RE: Loma Alegre Subdivision
TRACTS 473 AND 474, UNIT 7, TOWN OF ATRISCO GRANT
Grading and Drainage Plan
Engineer's Stamp Date: 6/8/22
Hydrology File: L10D033

Based upon the information provided in your submittal received 10/25/22, the Grading & Drainage Plan **is not** approved for Grading Permit. The following comments need to be addressed for approval of the above referenced project:

LOMA ALEGRE SUBDIVISION
GRADING PLAN

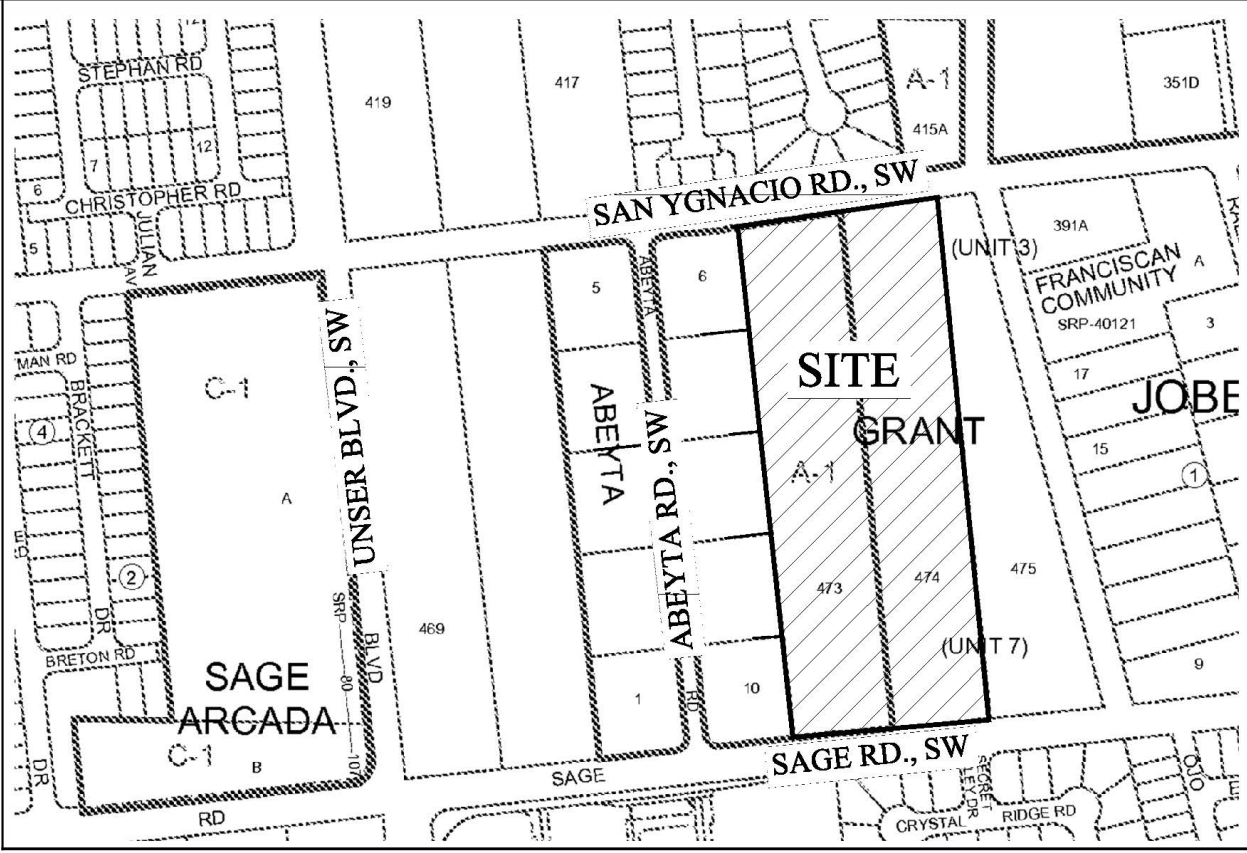
1. Please insert north arrow.
2. Include project benchmark and datum.
3. Include drainage calculations for lots 1 through 8 and 17 through 21.
4. Change Tract 476 to 473 under "Location".
5. Correct a typo of "Are" in the "Area @ the Throat".
6. Verify the Retention Volume Provided = 6,484.70 CF under "Lot 22 – Volume requirements" since the same item listed in the table shows 6,824.35 CF.
7. Add cross-sectional details for Loma Alegre Road, Sandia Sunrise Ct and Zia Valley Ct. Add more FL and TC elevations for all three proposed roads.
8. Drainage covenants will be required.
